**Errata for the
PCI Express® Base Specification
Revision 3.1,
Single Root I/O Virtualization and
Sharing Revision 1.1,
Address Translation and Sharing
Revision 1.1, and M.2 Specification
Revision 1.0**

December 13, 2017

**Errata for the PCI Express Base Specification Rev. 3.1a,
SR-IOV Rev. 1.1, ATS Rev. 1.1, and M.2 Rev. 1.0**

B253 LCRC and Sequence Number Rules (TLP Transmitter)

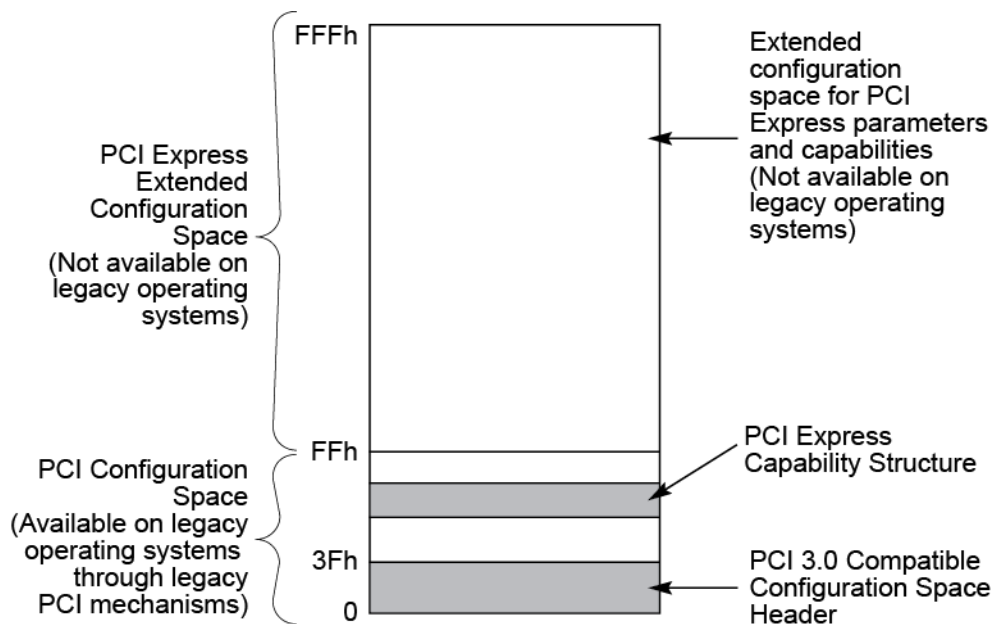
In Section 3.5.2.1, page 196, line 26, make the following changes:

AckFactor represents the number of maximum size TLPs which can be received before an Ack is sent, and is used to balance Link bandwidth efficiency and retry buffer size – the value varies according to Max_Payload_Size and Link width, and is defined in Table 3-7, Table 3-8, and Table ~~3-6~~.

Figure 7-132: Secondary PCI Express Extended Capability Structure

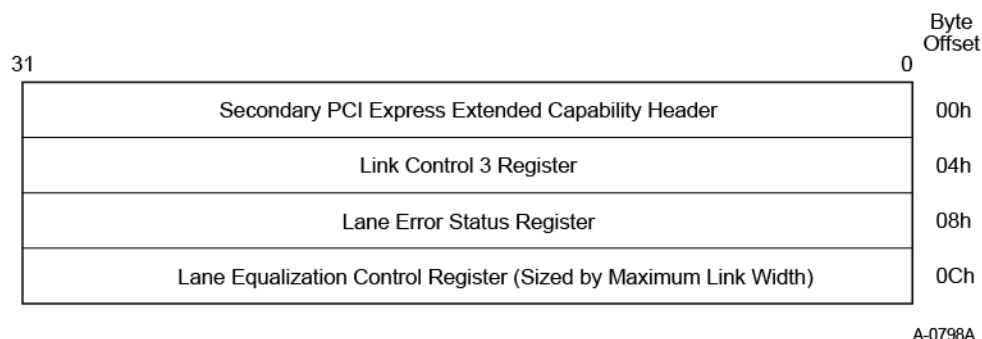
In Section 7.27, page 857, Figure 7-132, change the name of the field at offset 0Ch as follows:

Lane Equalization Control Register (Sized by Maximum Link Width)

Figure 2-5: Translation Completion with No Data

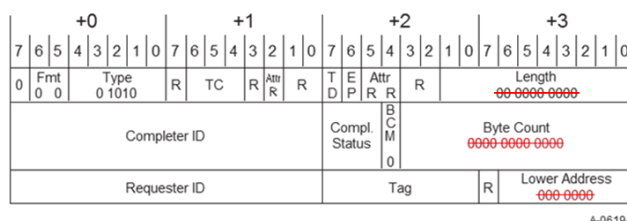
In the ATS Specification, Section 2.3, page 25 Figure 2-5 make the following changes:

Figure 6-20. PASID TLP Prefix

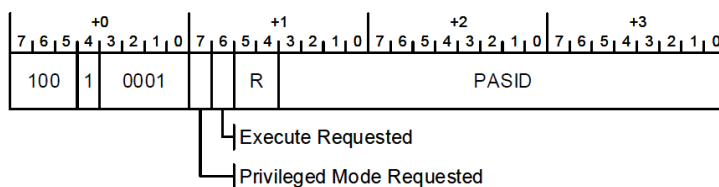
In Section 6.20.2, page 629, Line 17, replace Figure 6-20 and update Table 6-13 as follows:

A TLP may contain at most one PASID TLP Prefix.

Figure 6-10: Multi-Function Arbitration Model

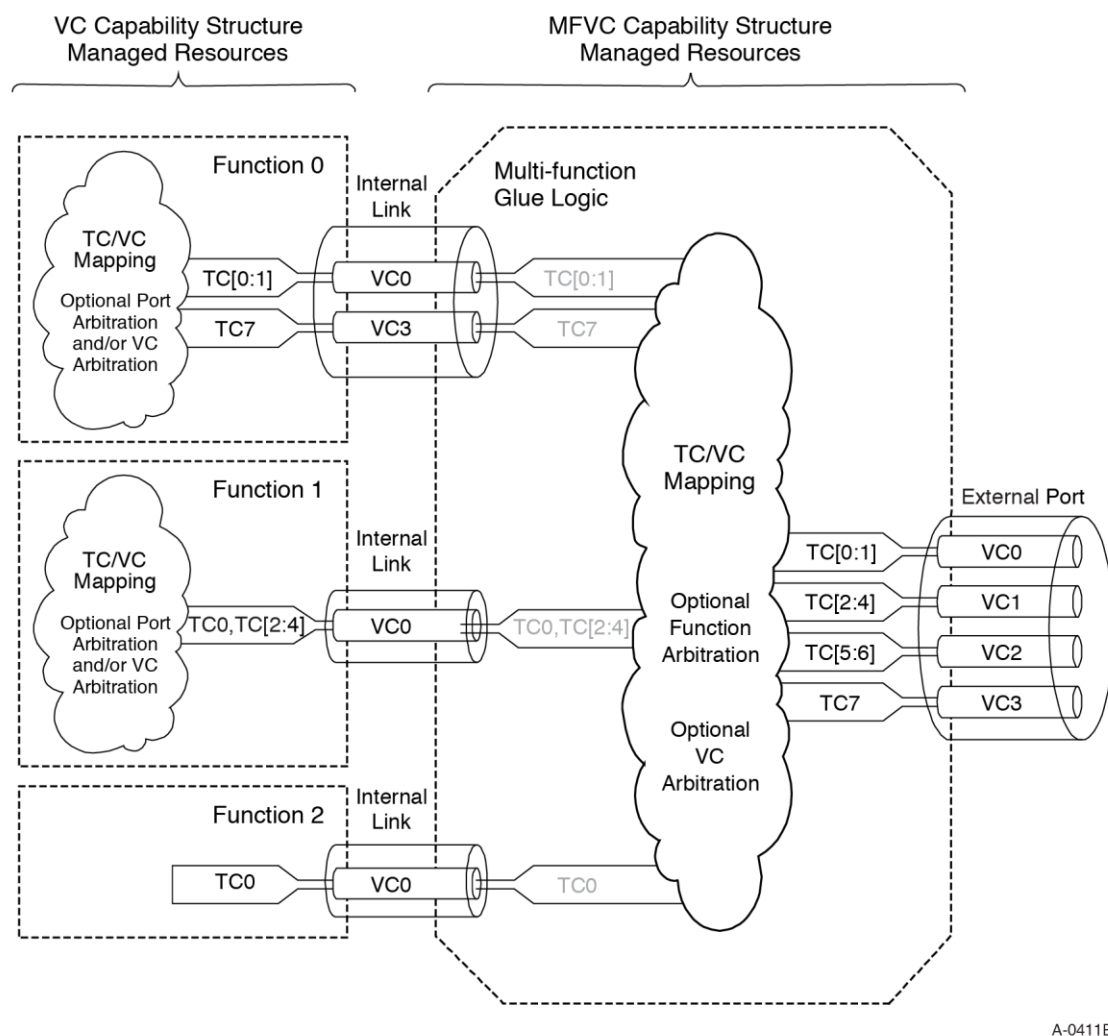
In Figure 6-10, Section 6.3.3.4, page 550, change Function 1 flow labeled “TC[2:4]” to “TC0, TC[2:4]”

and change “Egress Port” to “External Port”

Figure 10-8 64-bit Translation Request Header

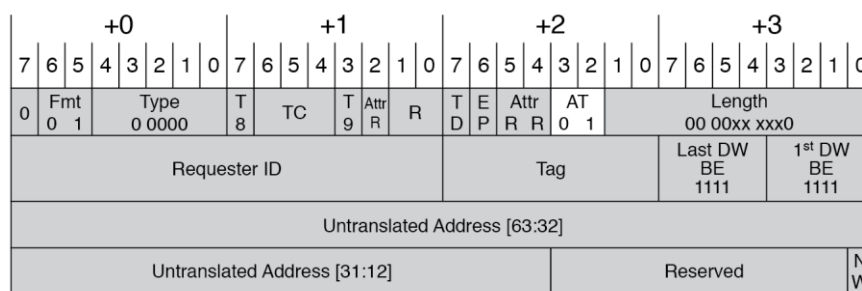
In ATS 1.1, page 22, Figure 2-4 change the length field 00 000xxx xxx0

Figure 10-9: 32-bit Translation Request Header

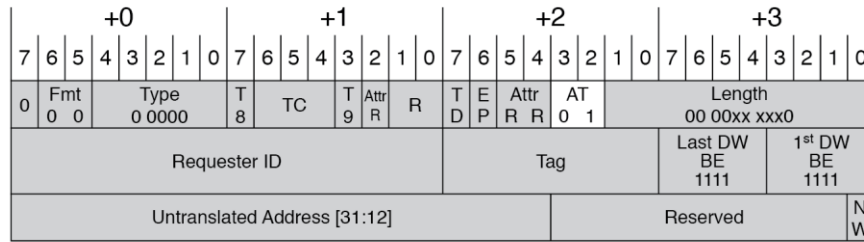
In ATS 1.1, page 23, Figure 2-3 change the length field 00 00~~0xx~~ ~~xxx~~0

Figure 7-10: PCI Express Capability Structure

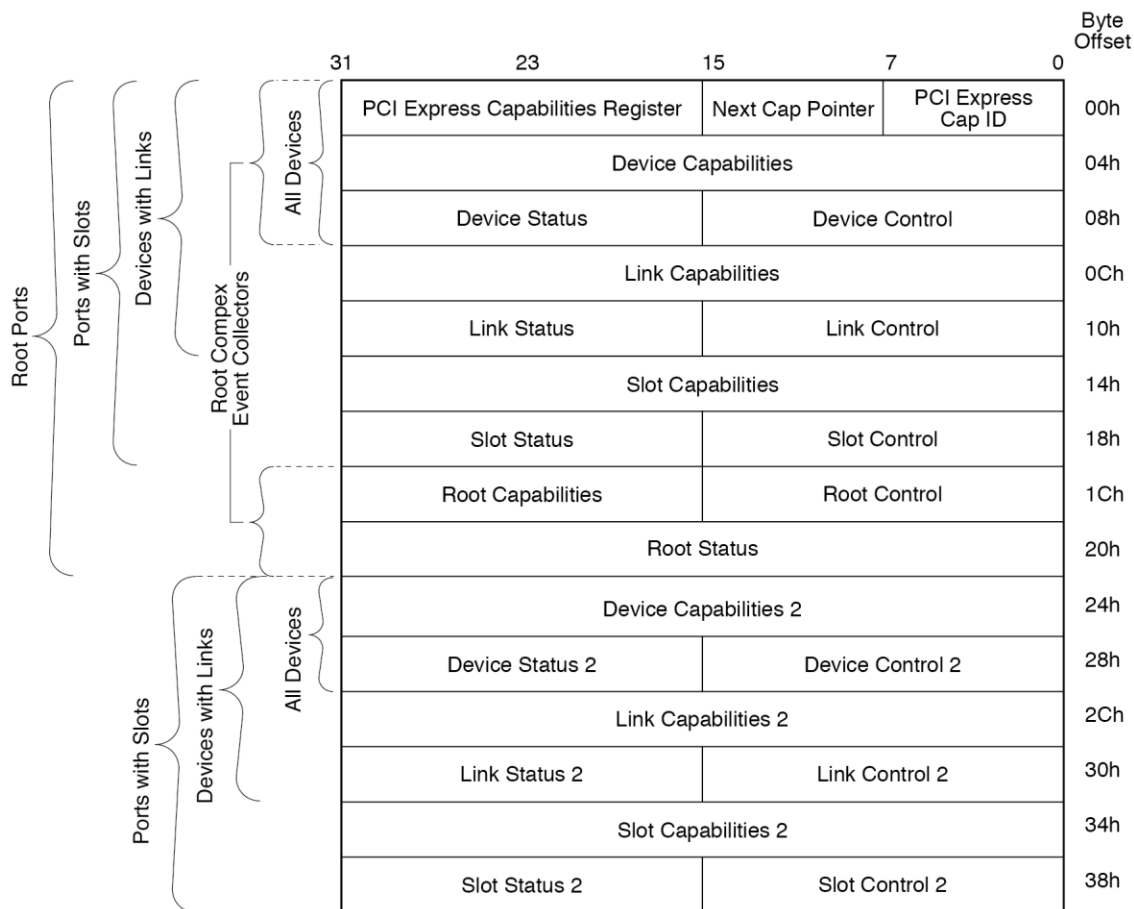
In Figure 7-10, Page 683, add the 3 braces shown at the left (the text was present in Base 3.1a but the braces were missing):

Figure 2-xx Hierarchy ID Message

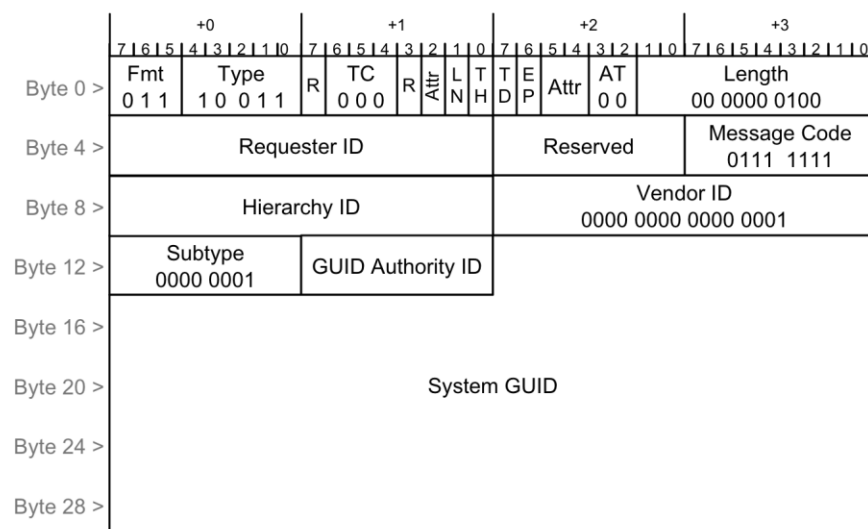
In the Hierarchy ID ECN, page 4, Figure 2-xx:

- Change the “Type” field to ~~01~~10 011
- Change the “Tag” field at byte 5 to “Reserved”
